ADDENDUM NO. 2

Three Rivers Community Schools – New Transportation Facility
58420 Haines Road
Three Rivers, MI 49093

A/E Project 5-5138

ADDENDUM 002

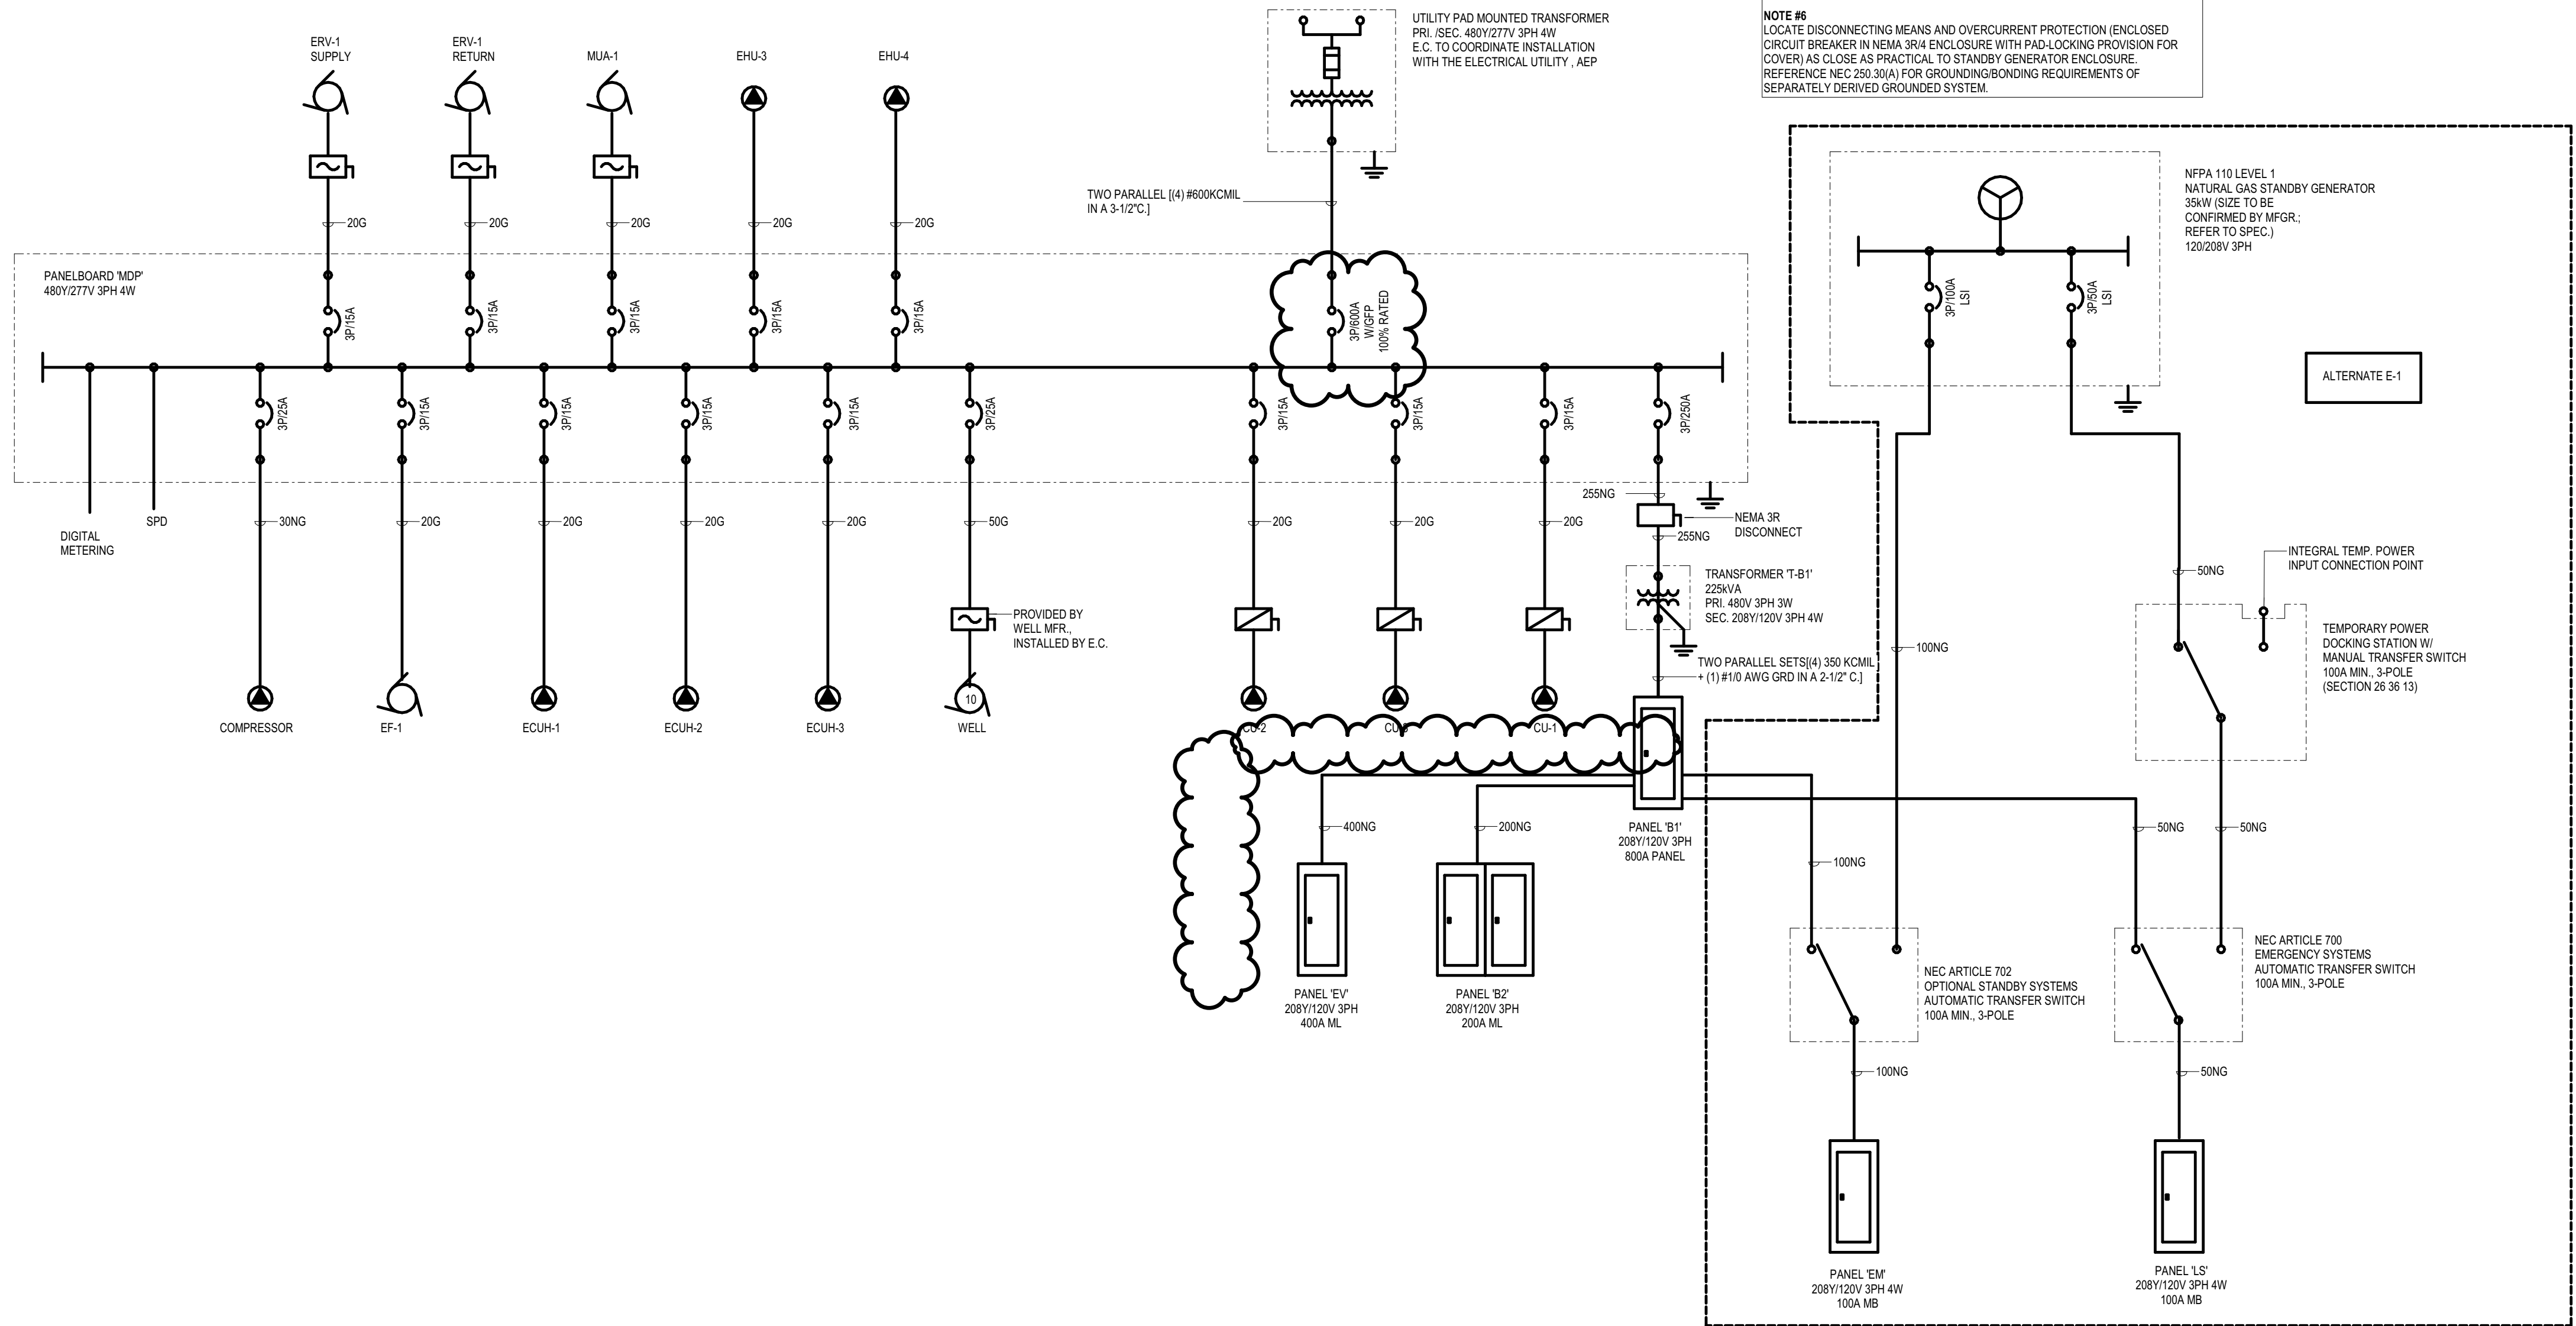
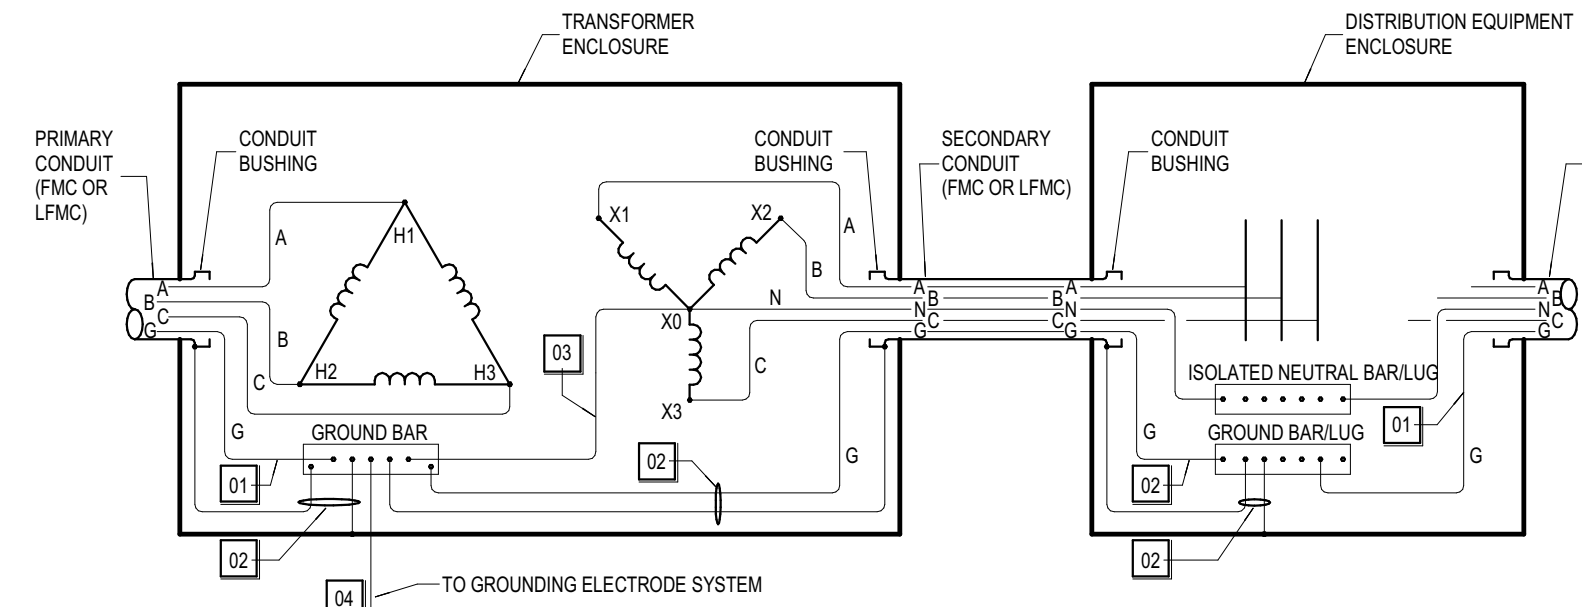
ITEM NO. 10 **SHEET E4.01 POWER DISTRIBUTION ONE-LINE DIAGRAM & ELECTRICAL DETAILS (REISSUED)**

- A. Refer to the plan for the complete removal of Panel 'A'.
- B. Refer to the plan for the 'MDP' to have a main breaker of 600A, GFCI rated and 100% rated.

4
E5.10
BUS PARKING PEDESTAL POWER
1" = 1'-0"

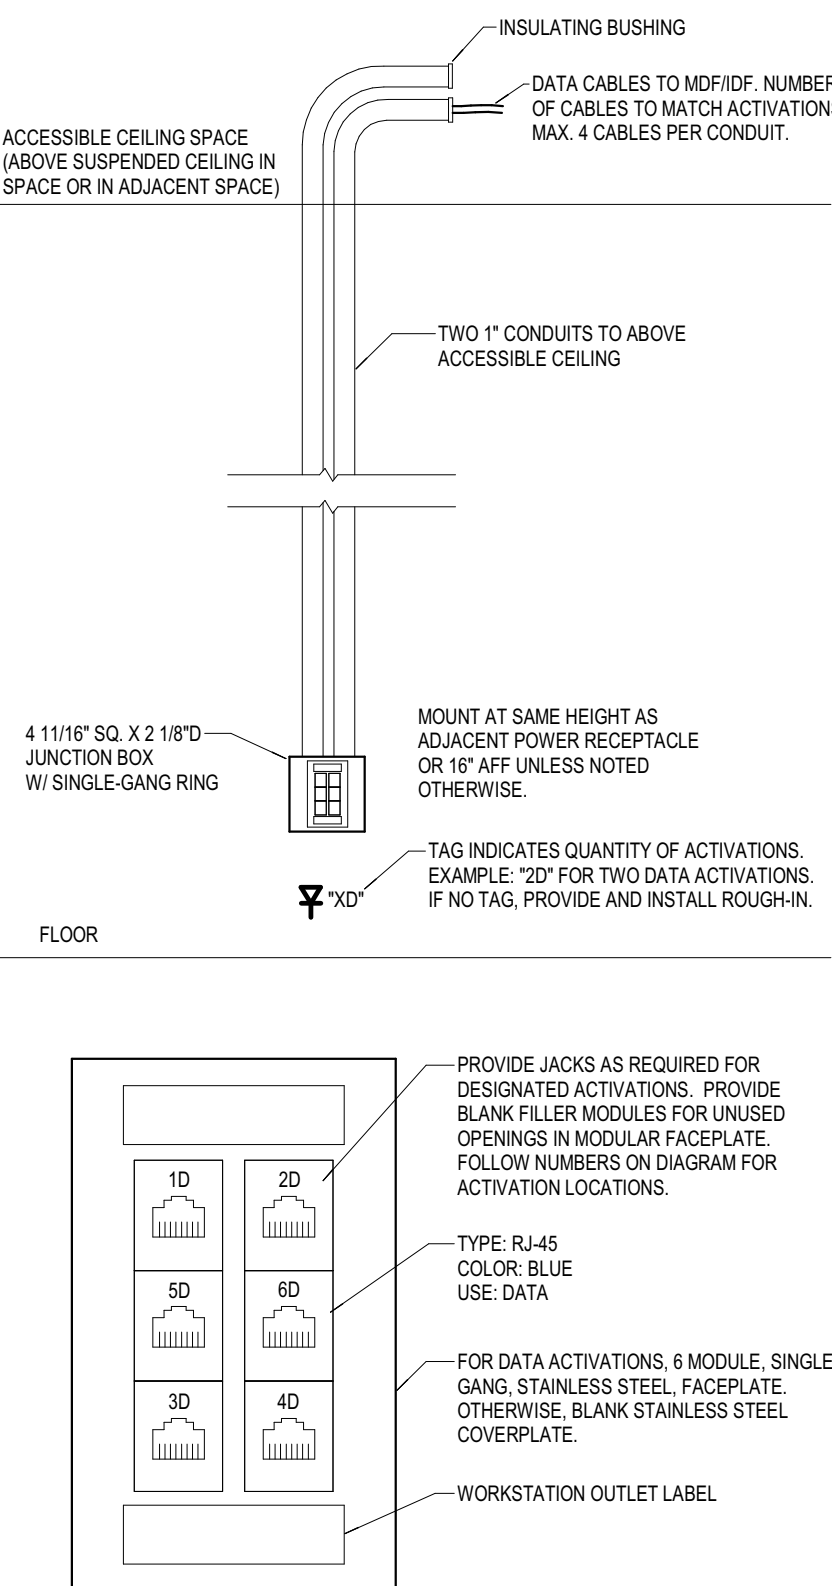
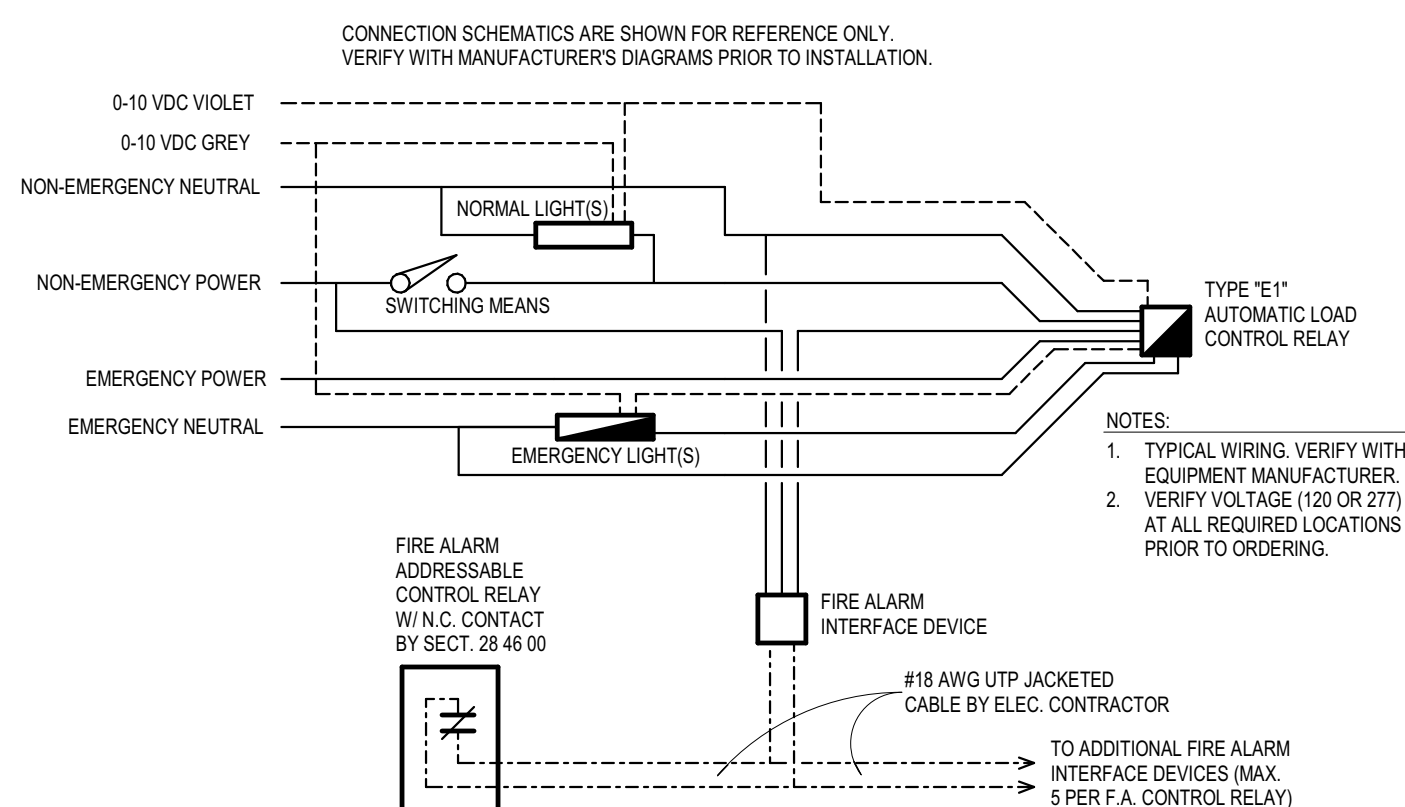
Bid Category No. 5 – General Trades is to furnish 4”X4”X1/4” Tube Steel Columns as detailed in 4/E5.10 and 6/E5.10. Tube Steel shall be Hot-Dip Galvanized in addition to identified prime and two coats of epoxy paint. **Bid Category No. 9 – Electrical and Low Voltage** is to install all tube steel and is responsible to Provide all other components for installation as detailed. See Plan E2.10 for locations.

- A. Refer to the plan for the additional note on site lighting pole 'SB' for access points and cameras and height changes on fixtures type 'SB' and 'SA2'.
- B. Refer to the plan for updated notes on the steel supports on the bus charging station and pedestal receptacle details.

SITE ELECTRICAL PLAN

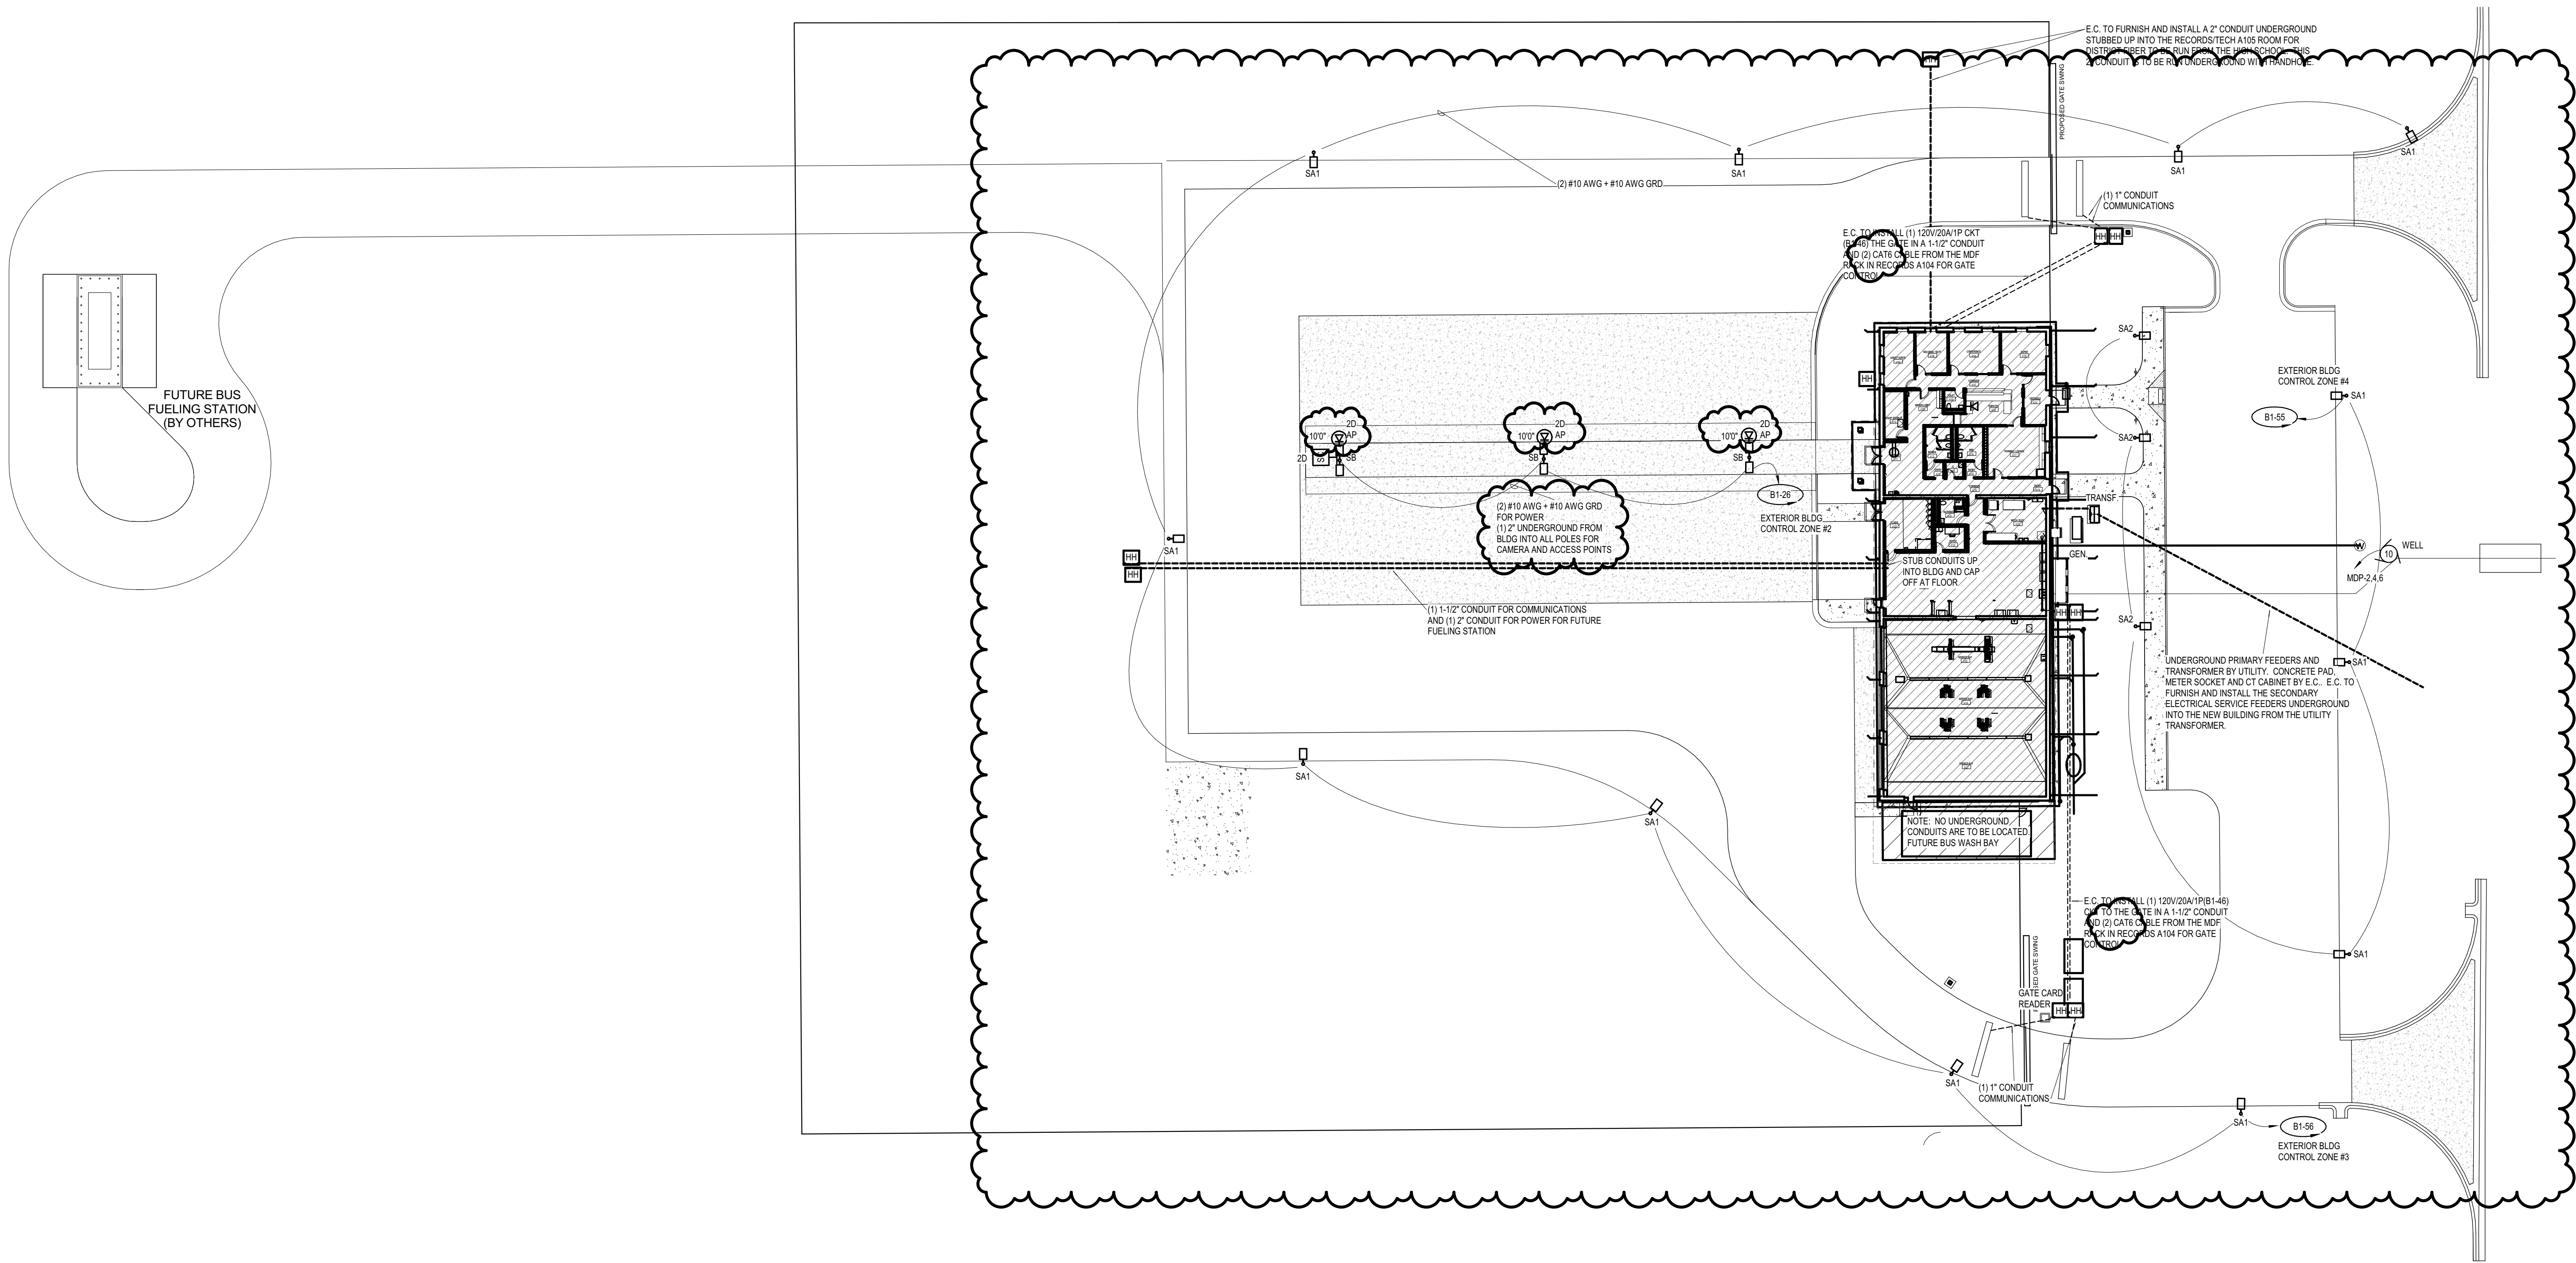
ITEM NO. 13 **SHEET ES2.01 SITE ELECTRICAL PLAN (REISSUED)**

- A. Refer to the plan for the addition of a category 6 cable out to both drives for the gate control.
- B. Refer to the plan for the addition of access points with underground conduit to the site lights in the bus parking area.
- C. Refer to the plan for new layout of site lighting poles.
